Model Administrative Change Notice

1. Document Number:	MDL-MGR-GS-000003	2. Revision:	01	3. ACN:	01
4. Title:	Development of Earthquake Ground Motion Input for Preclosure Seismic Design and Postclosure Performance Assessment of a Geologic Repository at Yucca Mountain, NV				
5. No. of Pages Attached	9

Figure 6.2-1. Hazard Curve at Point A for Peak Horizontal Ground Acceleration

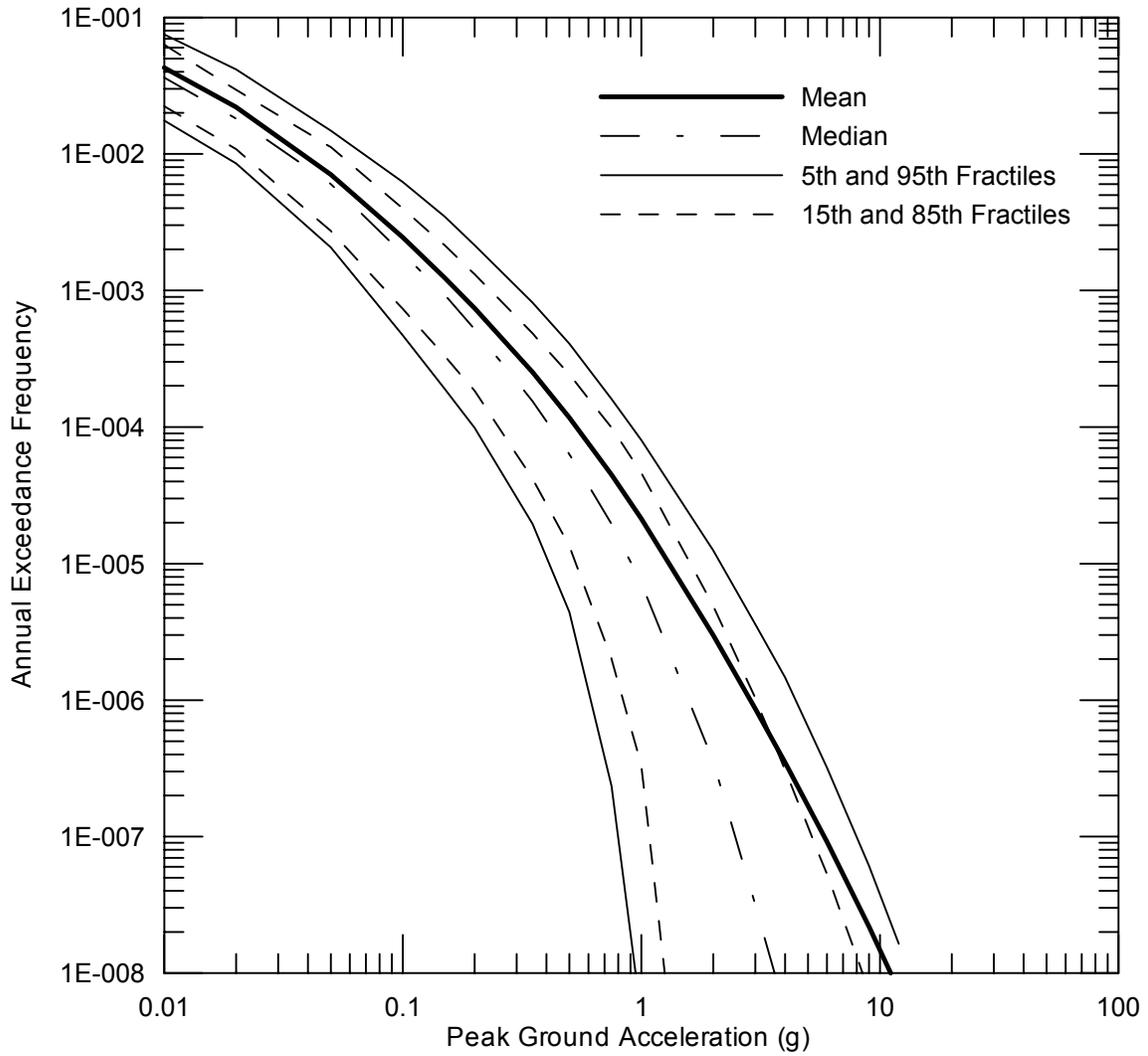
7. Affected Pages	8. Description of Change:
6-84 through 6-87	<p>Editorial changes to captures in Figures 6.2-1, 6.2-2, 6.2-3, and 6.2-4.</p> <p>As described in Condition Report 6134, the graphic componenets of Figures 6.2-1 through 6.2-4 are scrambled and need to be changed to agree with their captions, which are correct:</p> <ul style="list-style-type: none"> • The graphic componenet of Figure 6.2-1 is exchanged with the graphic component of Figure 6.2-4 such that Figure 6.2-1 shows the hazard curve for Point A for peak horizontal ground acceleration and Figure 6.2-4 shows the hazard curve for Point A for peak horizontal ground velocity. • The graphic componenet of Figure 6.2-2 is exchanged with the graphic component of Figure 6.2-3 such that Figure 6.2-2 shows the hazard curve at Point A for 10 Hz horizontal spectral acceleration and Figure 6.2-3 show the hazard curve at Point A for 1 Hz horizontal spectral acceleration. <p>This change was identified in CR 6134</p>
